From: Hansen, John P (DFW) <John.Hansen@dfw.wa.gov>
Sent: Thursday, July 09, 2015 8:40 AM
To: Lindsey Ozbolt
Cc: Hendrix, Leah (DFW); Peoples, Marty D (DFW)
Subject: RE: CU-14-00006 WDFW Hearing Examiner Recommendation
Attachments: DAM AHEAD.pdf; Site Map Old Hwy 10 Signs.pdf

Please find attached the Hearing Examiner's recommendation regarding CU-14-00006 & SD-14-00003 for WDFW HWY 10 CUP, SSDP, & SCUP. It has also been placed on our website.

YAKIMA RIVER ~ HIGHWAY 19
ACCESS SITE
RCC PROPOSAL
EXISTING OVERALL SITE

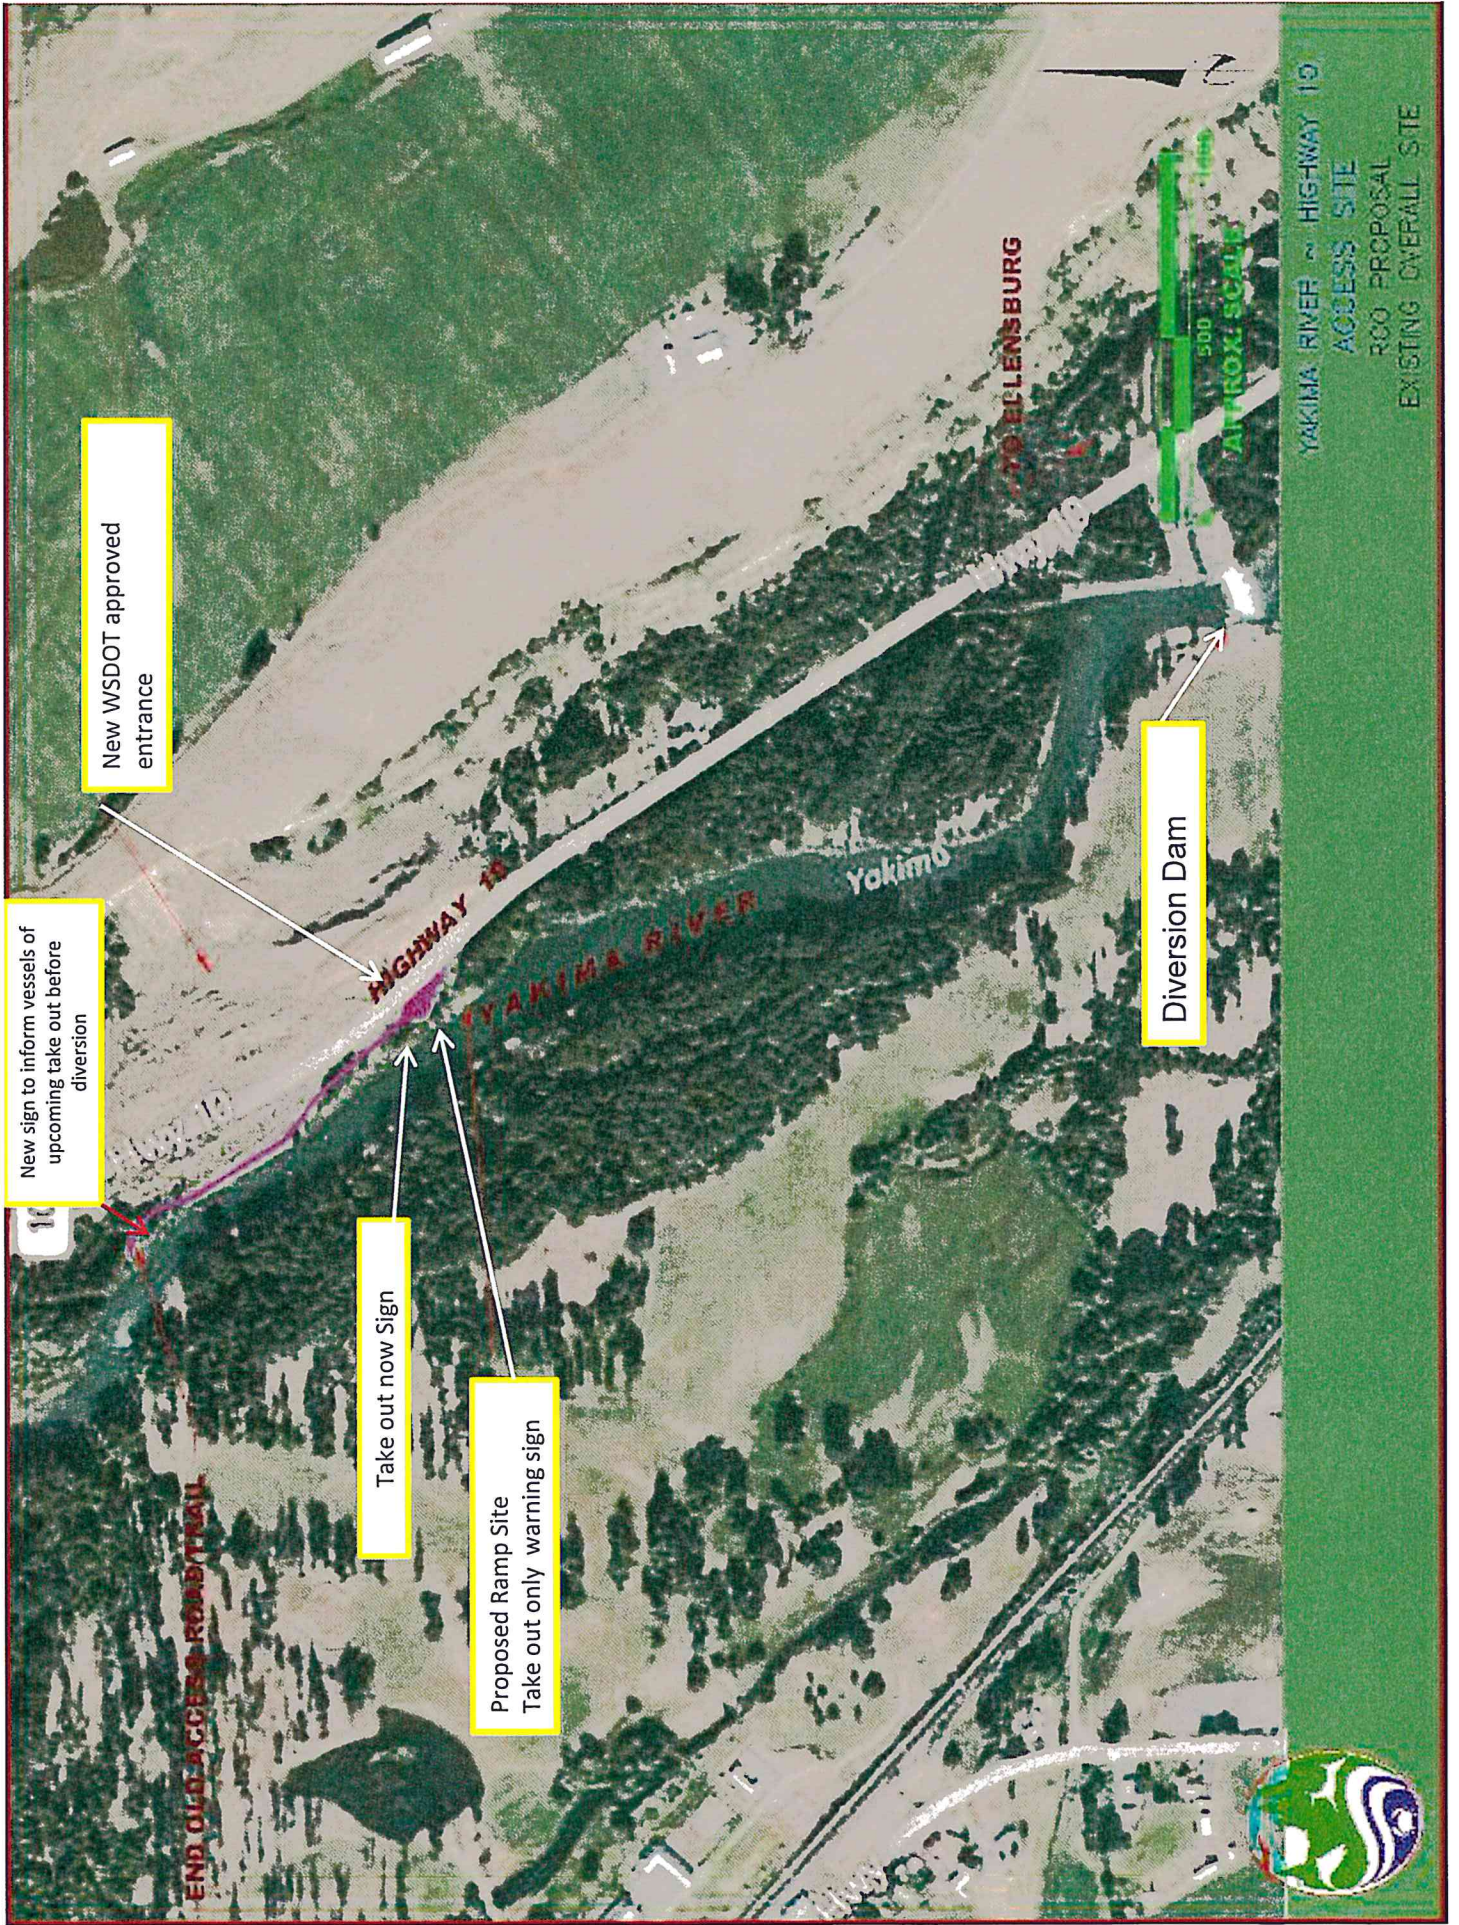
I'd recommend 36"W x 48"H for the signs to be seen from the middle of a river along with the warning sign at the top of the ramp. For comparison this is the size of a speed limit sign on a state highway (interstate speed limit signs are 48"W x 60"H). For the Attention sign the recommendation is 24"W x 36"H.

The top two signs need to be legible from the middle of the Yakima River while bobbing in an inner tube . The Warning sign needs to be legible at the top of the boat ramp. These three I'm thinking should be 3'x3'. The Attention sign, I'm thinking 2'x2'. How's that sound? Is that big enough?

Please take the punctuation off of the 'Attention' sign & put a line between the statements to match formatting of the other three signs. 'Take out' is an official boating activity as well as a good way to get Chinese food☺ Thank you Peggy. JJH

Please put department logos on all 4 signs in the attachment above and then send them back to me.

Lindsey,
The WDFW sign team has revised the layout as attached. Thanks,

Here are the drafts for the signs. Please let me know if you have any changes or corrections.
Thanks.
Peggy

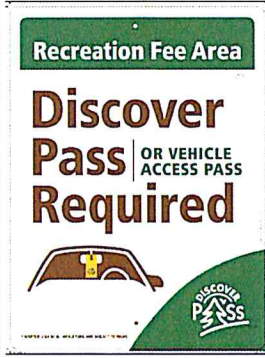
There is not any camping that will be allowed at this site. This is for day use only. Please remove those signs regarding camping. The signs should read no overnight parking or camping. We do not allow camping at any of our sites along the Yakima River, Thanks!!
